EQUIPMENT/FURNISHINGS - RH REFRESHMENT CENTER AND LH FORWARD CABINET REINFORCEMENTS INSTALLATION

Structural analysis with RH Refreshment center and LH forward cabinet indicates the need for new reinforcements installation.

To install reinforcements on the RH refreshment center and LH forward cabinet, and to replace rivets of the floor support of the RH Refreshment Center.

FIGURE 6 - LH FORWARD CABINET - REWORK - GROUPS 6 AND 7
(Sheet 1 of 4)

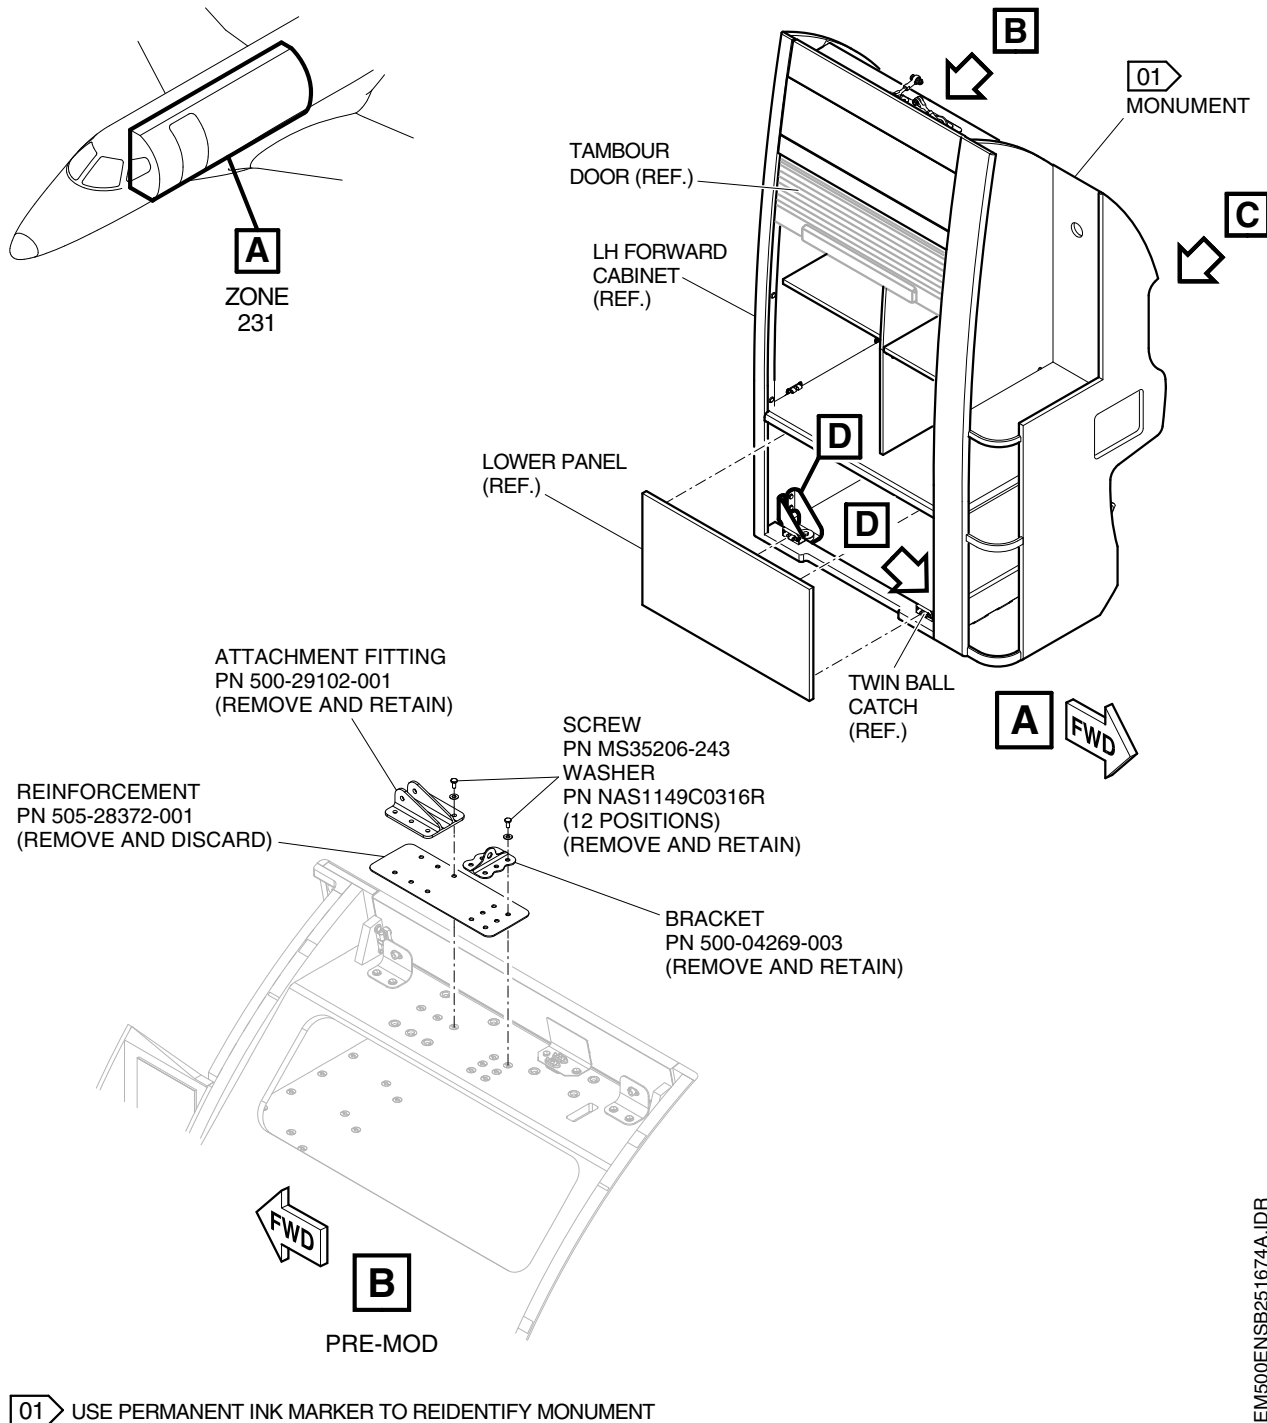
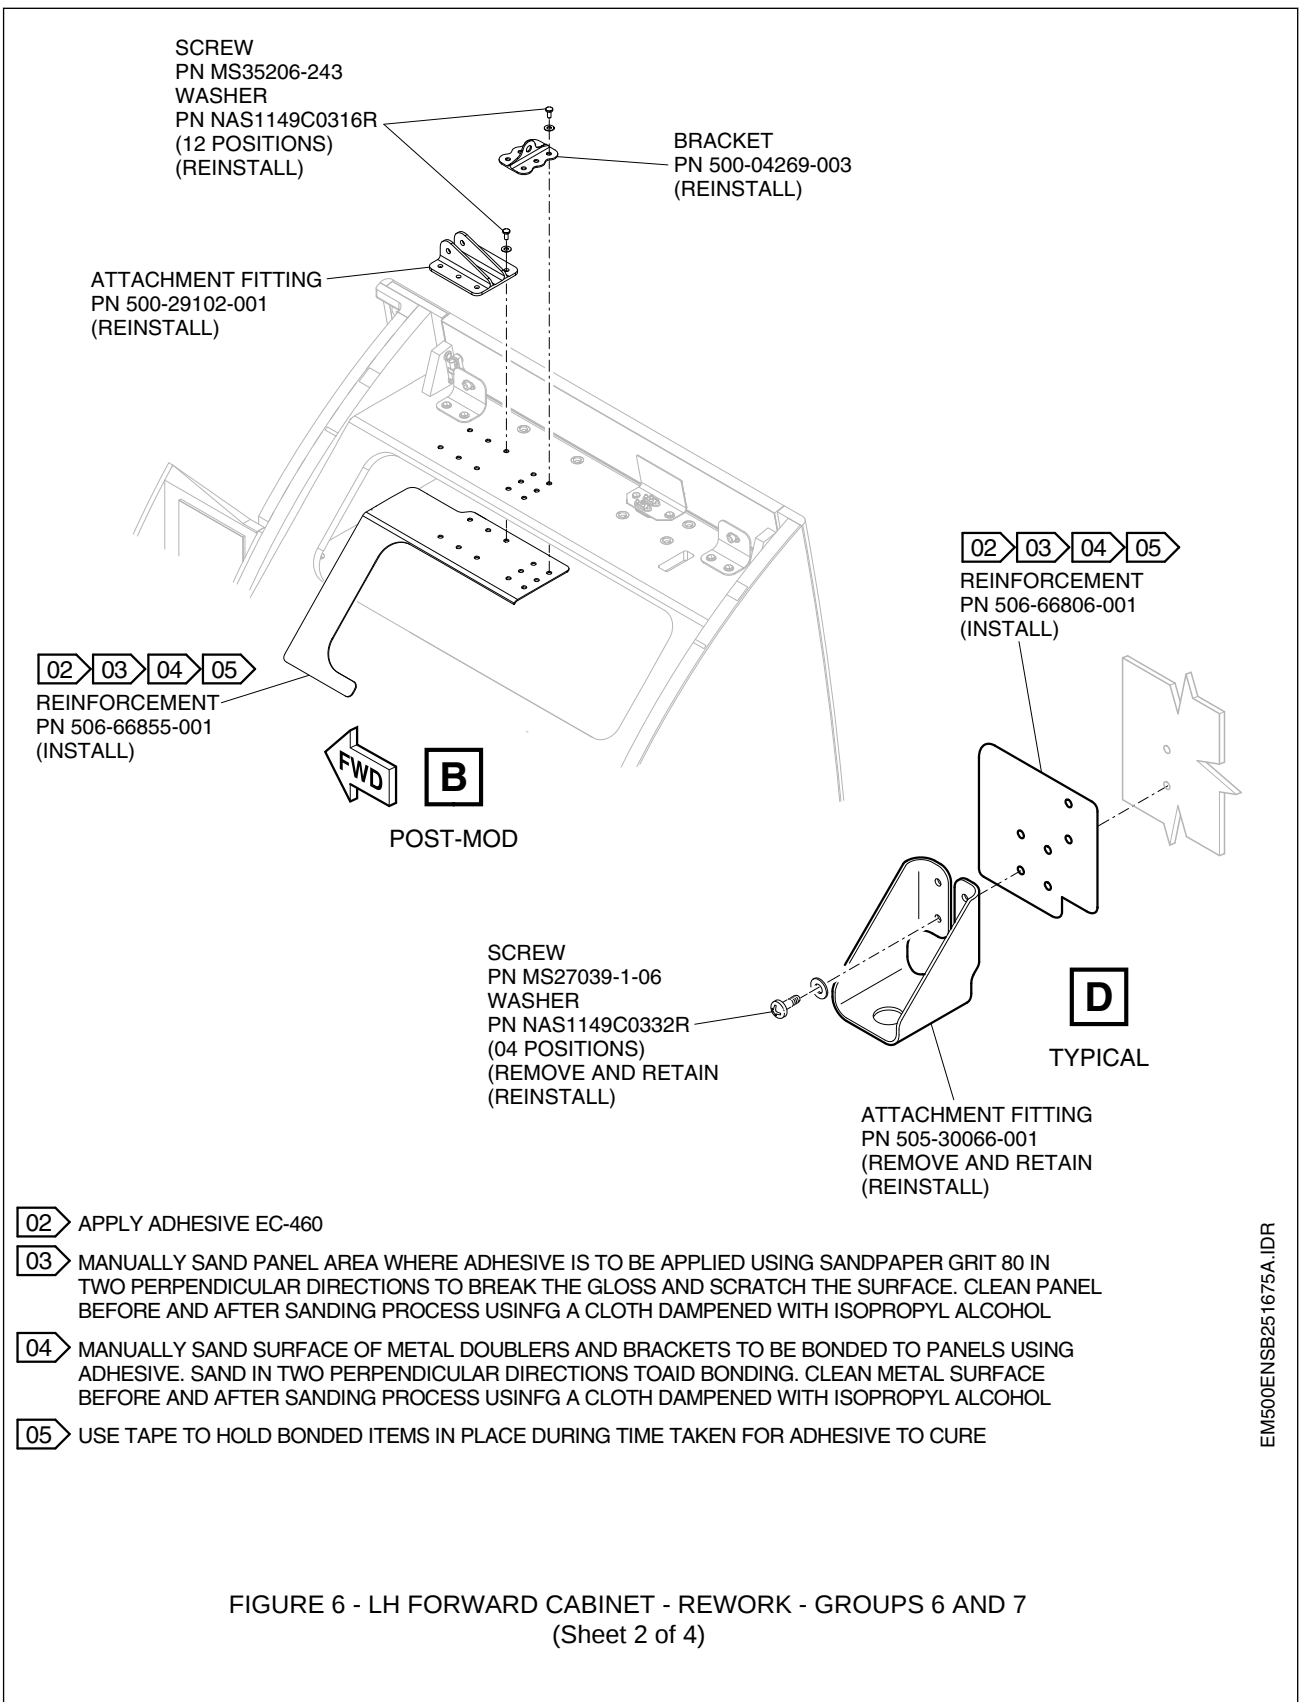
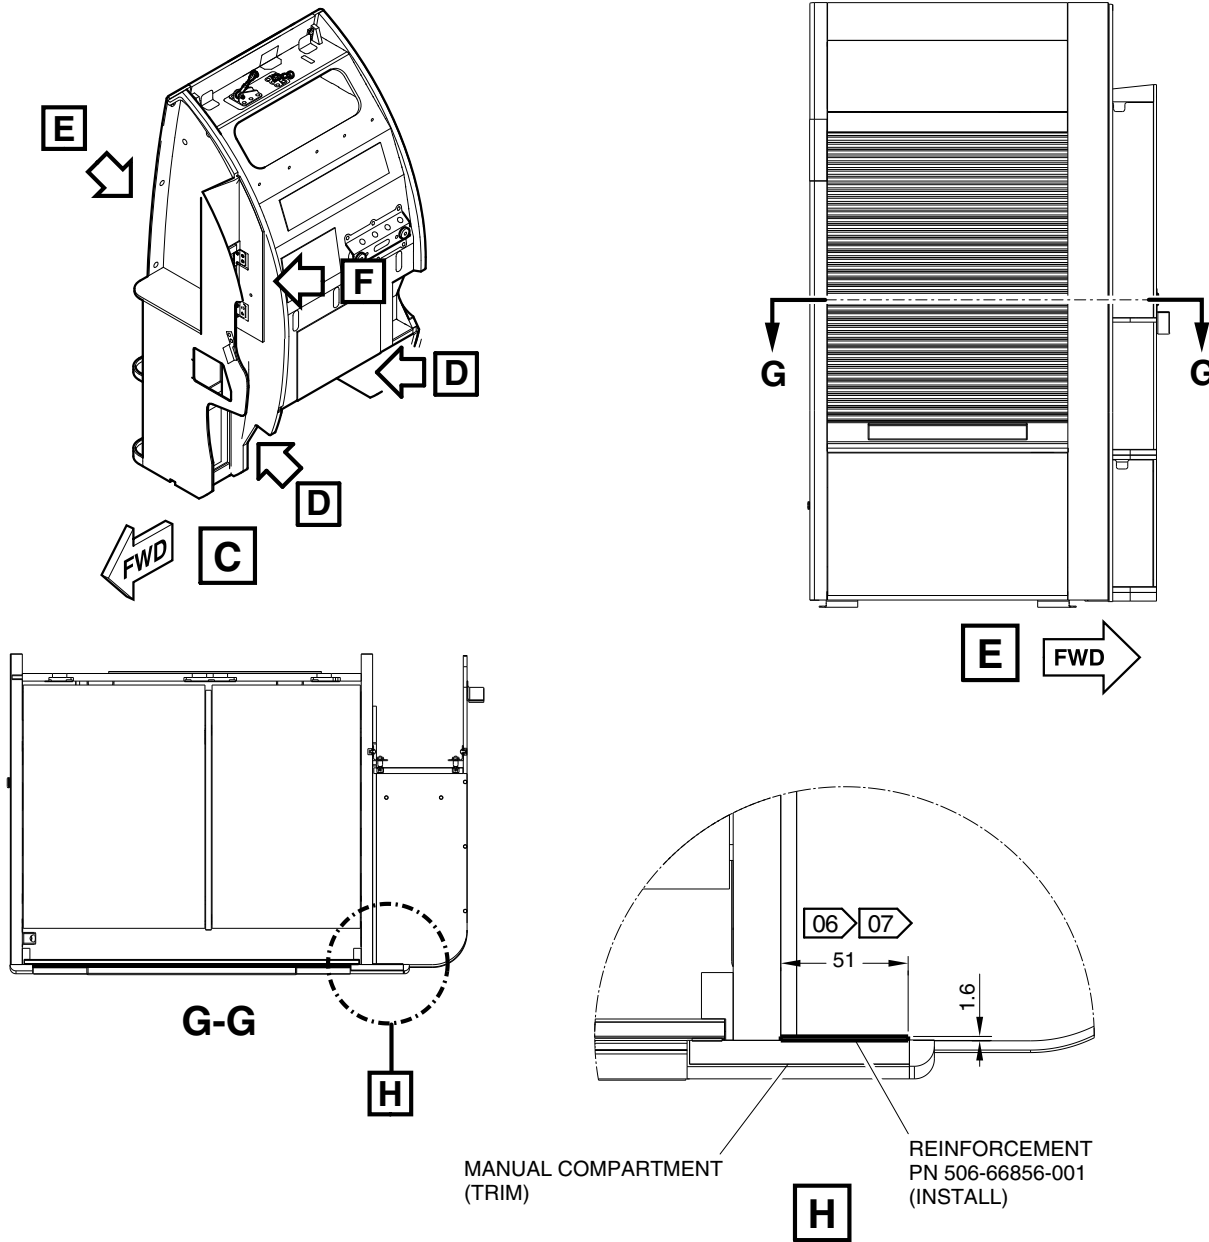
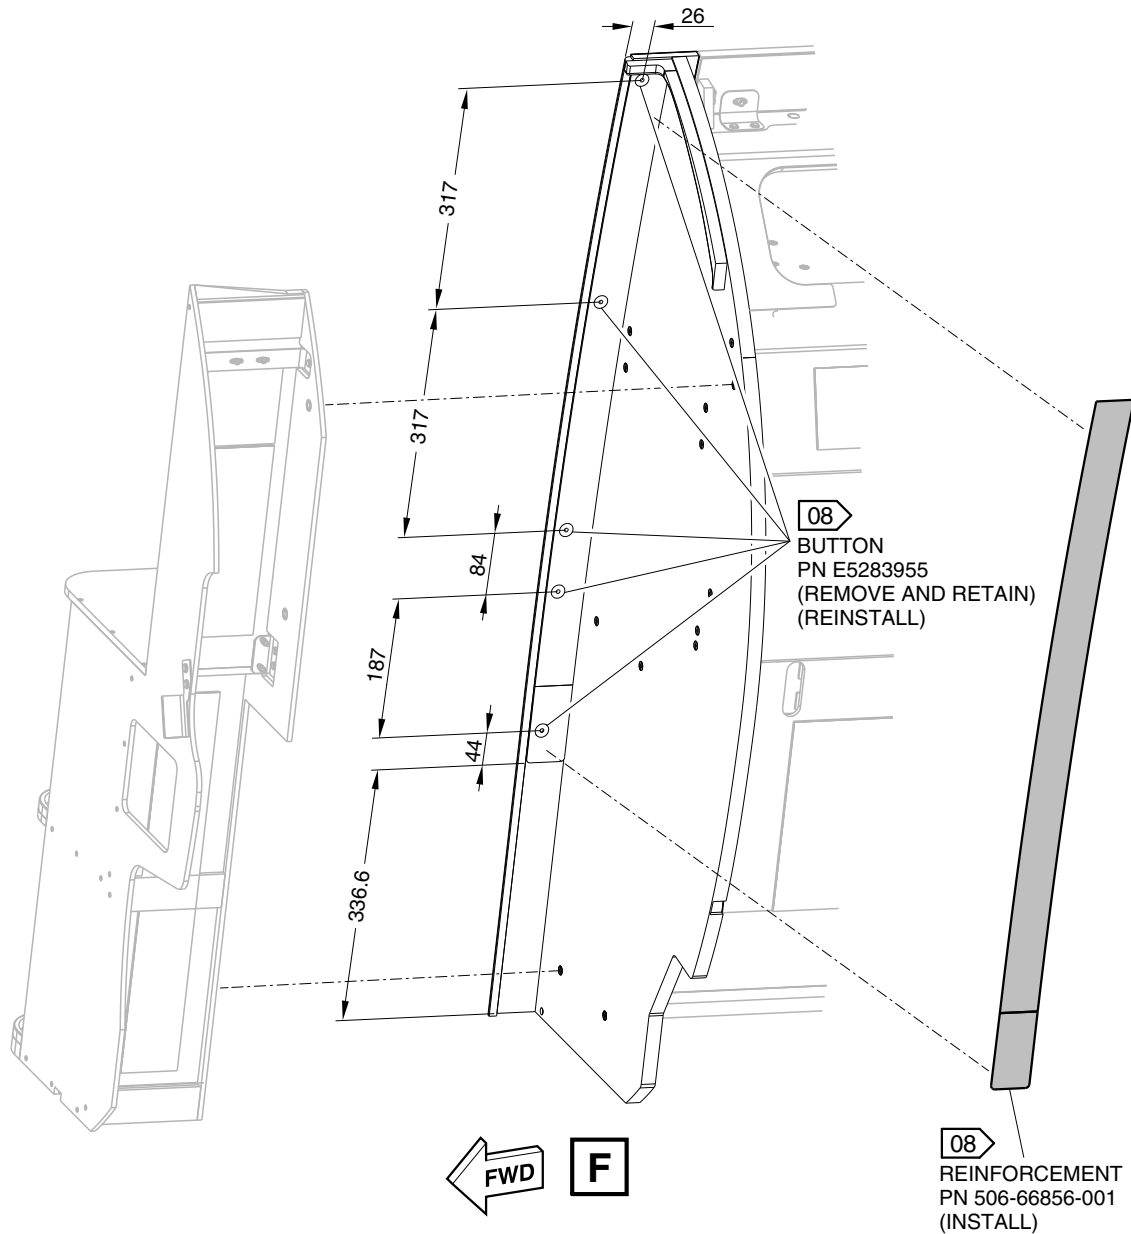
- (10) Remove the LH forward cabinet. Refer to [AMM TASK 25-26-01-000-801-A/400](#) - LH Forward Cabinet - Removal.
- (11) Rework the LH forward cabinet according to instructions given in [Figure 6](#).

06 TRIM MANUAL COMPARTMENT

07 APPLY PAINT IP1083-740 WITH PRIMER 20P20-3/K1G

02 APPLY ADHESIVE EC-460

08 POSITION, TRANSFER AND DRILL THE HOLES AS DIMENSION INDICATED
